MONTGOMERY COUNTY HISTORIC PRESERVATION COMMISSION
STAFF REPORT

Address:	54 Walnut Avenue, Takoma Park	Meeting Date:	9/20/2023
Resource:	Contributing Resource Takoma Park Historic District	Report Date:	9/13/2023
Applicant:	Steve Shira	Public Notice:	9/6/2023
Review:	HAWP	Tax Credit:	Pending
Permit Number:	1038899	Staff:	John Liebertz

PROPOSAL: Fence installation, hardscape alteration, and front porch alteration; additional after the fact approvals for shed installation, grading, and other yard alterations.

Figure 8: Site plan showing the proposed stone landing and stair (outlined in red), left. View of the concrete walkway to be demolished, right.

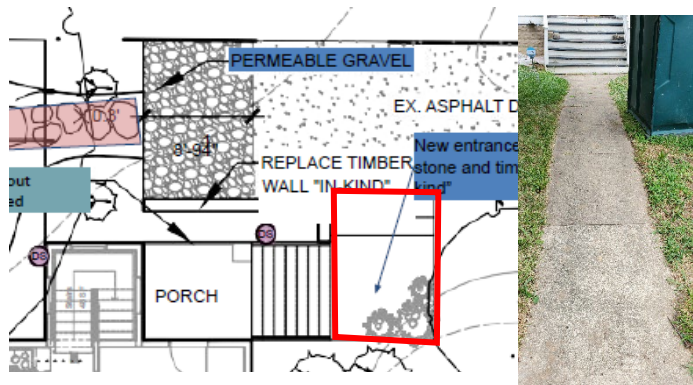
Staff finds the removal of the concrete walkway to be consistent with the applicable guidelines and recommends approval (Figure 8). The removal of this feature would not adversely affect the character defining features of the individual resource or the surrounding district.

Staff finds the proposed 8’x8’ stone landing and stair connecting the front porch to the driveway to be consistent with the applicable guidelines and recommends approval with conditions (Figure 8). The HPC regularly approves the use of stone walkways, landings, and walkways in the historic district, but staff requests additional design and material specifications for the stair and material specifications for the landing.

Figure 9: View of the proposed permeable gravel border (red arrows).

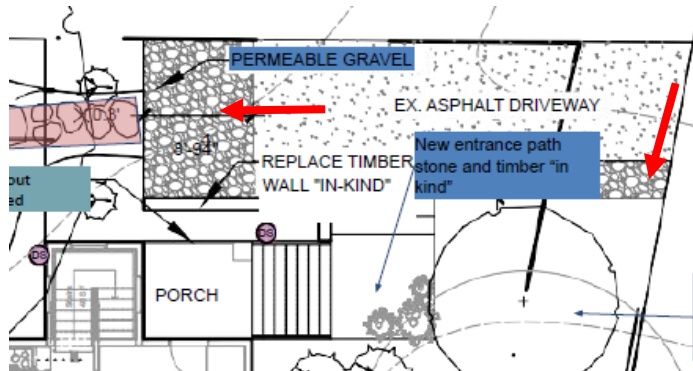
Staff finds the proposed permeable gravel driveway installed to the south and west of the existing asphalt driveway to be consistent with the applicable guidelines and recommends approval with conditions (Figure 9). The permeable surface would aid with stormwater management issues and would not adversely affect the character defining open space or landscape of the individual site or the surrounding historic district. Staff requests that the applicant submit specifications for the type/size of the gravel.

4' picket fence with capboard

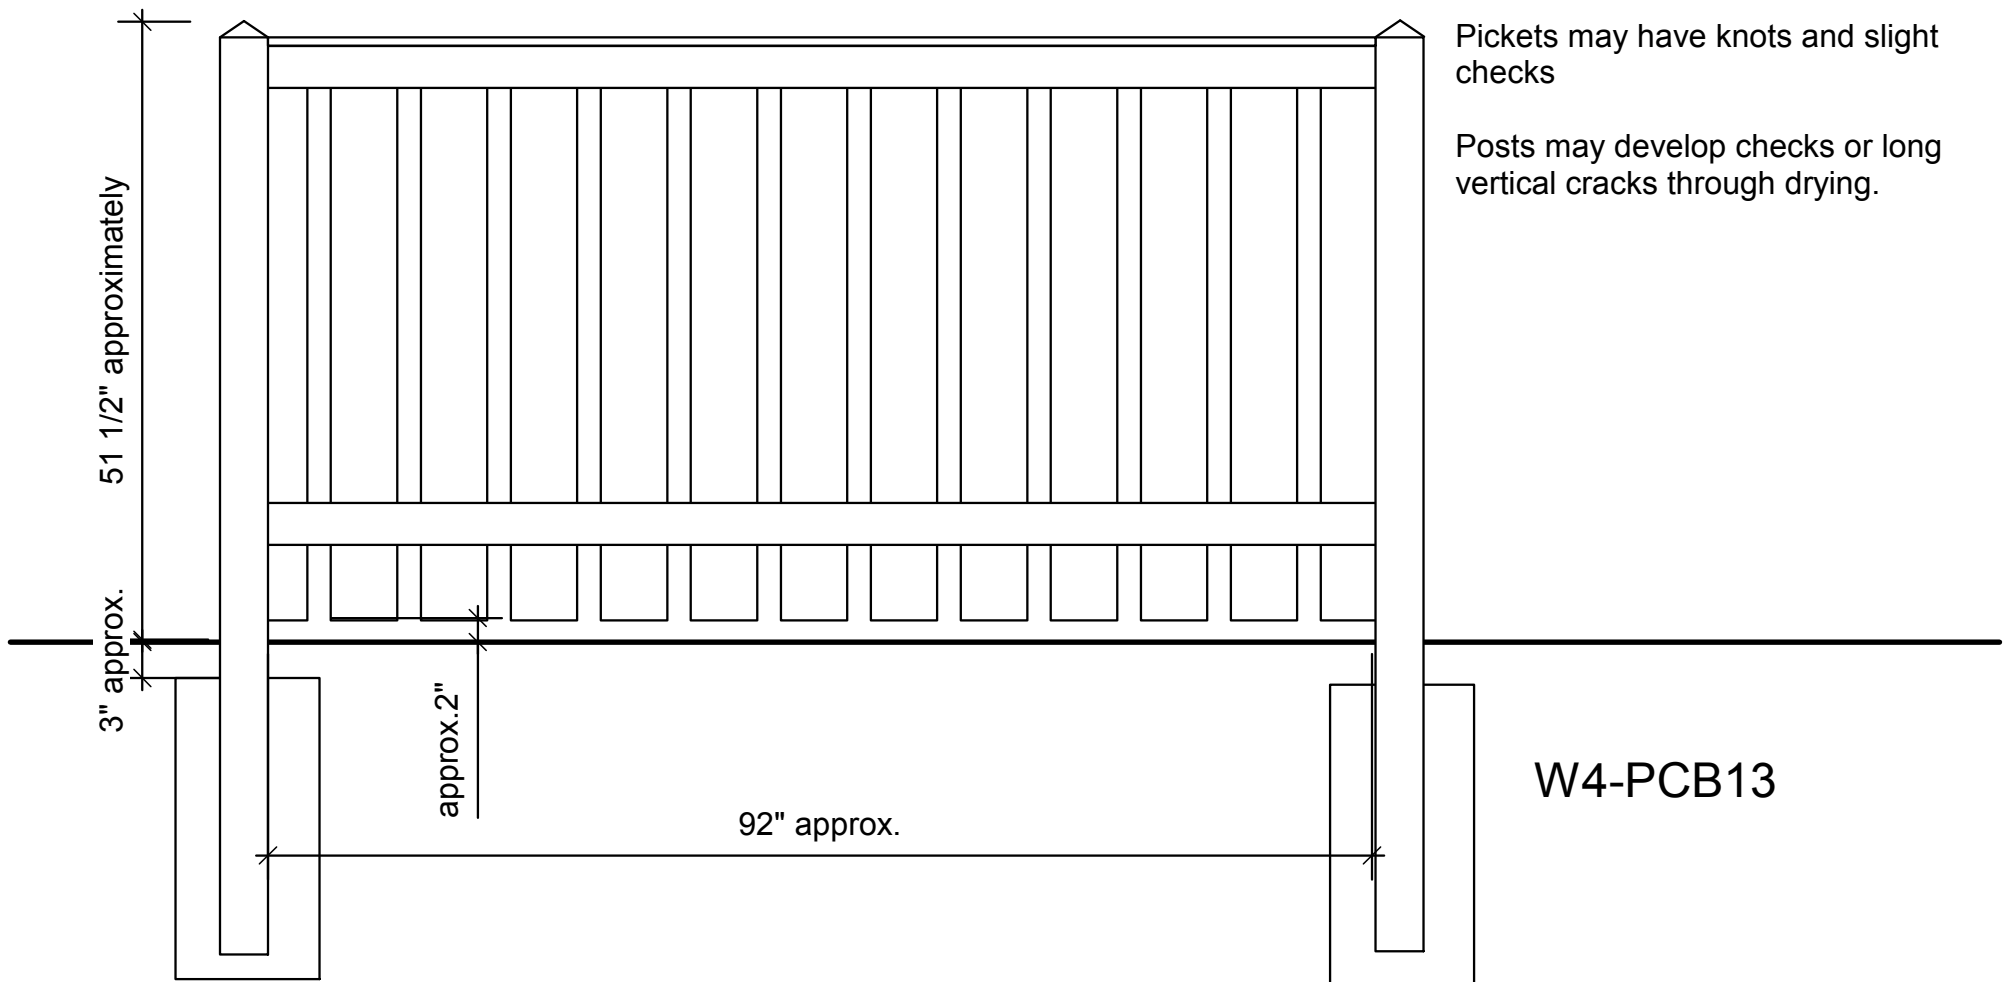
Staff finds that the installation of the cedar picket fence with cap board to be consistent with the applicable guidelines and recommends approval with conditions. The HPC regularly approves cedar picket fences of the proposed height (*Figure 3*). The fence is compatible with the streetscape and patterns of open space associated with Takoma Park. Staff requests that the applicant submit elevations and specifications for the proposed gates and note the location of the gate on Eastern Avenue on the landscape plan.

1. The applicant shall submit an updated site plan that shows the location of the proposed fence and gates, and specification for the proposed gates.
2. The applicant shall use wood, tongue-and-groove, porch flooring and submit materials specifications.
3. The applicant shall submit design and material specifications for the in-kind (wood) replacement of the porch stair, balustrade, railings, etc. This shall include the profile of the proposed railings.
4. The applicant shall submit material specifications for the proposed permeable gravel along the asphalt driveway.

**Existing porch
with bump out.
Bump out to be
removed.**

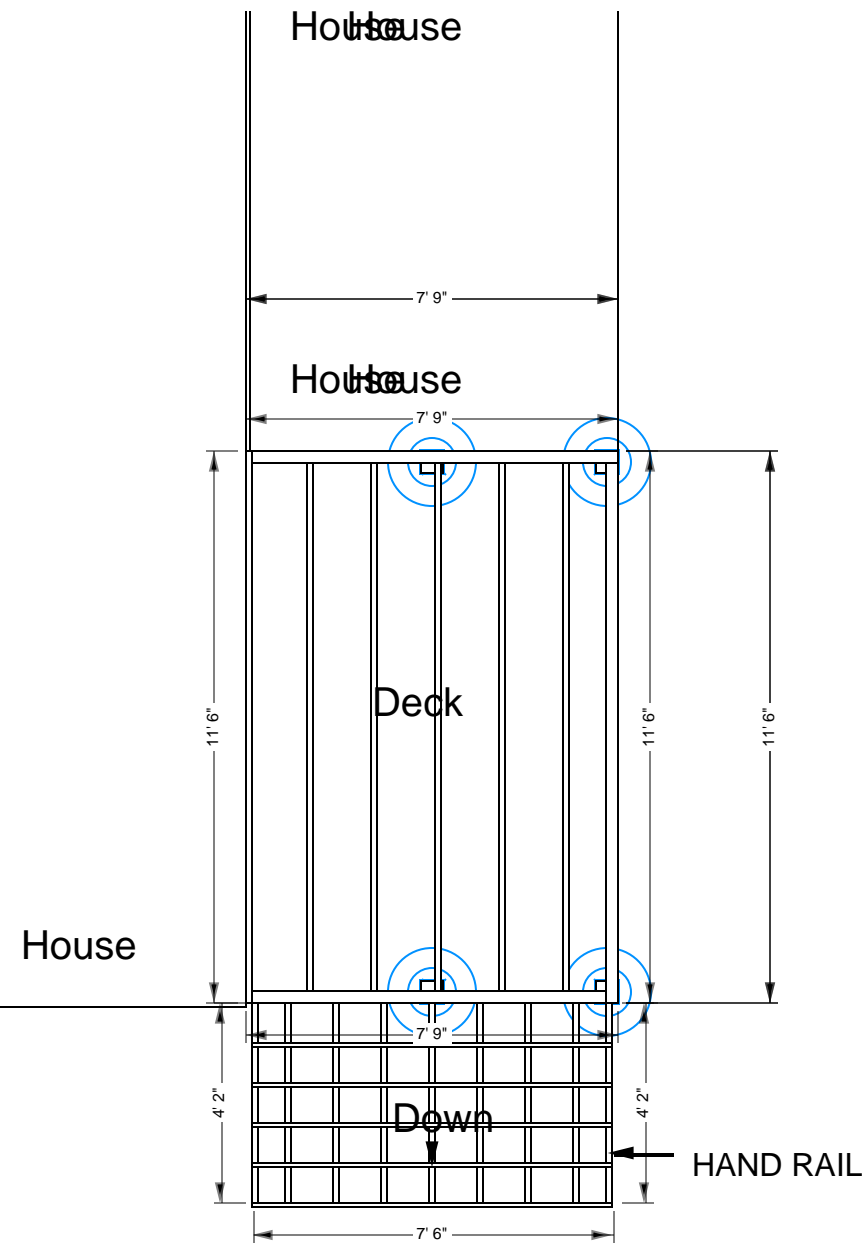
Staff finds that the demolition of the non-historic porch addition (bump-out) meets the applicable guidelines and recommends approval. As shown on the Sanborn Fire Insurance Maps and earlier photographs of the house, this is not original to the building and likely dates to the 1980s. Photographs depict its use as the landing for a no longer extant accessibility ramp (*Figure 2*). The removal of this element would restore the porch to its original design.
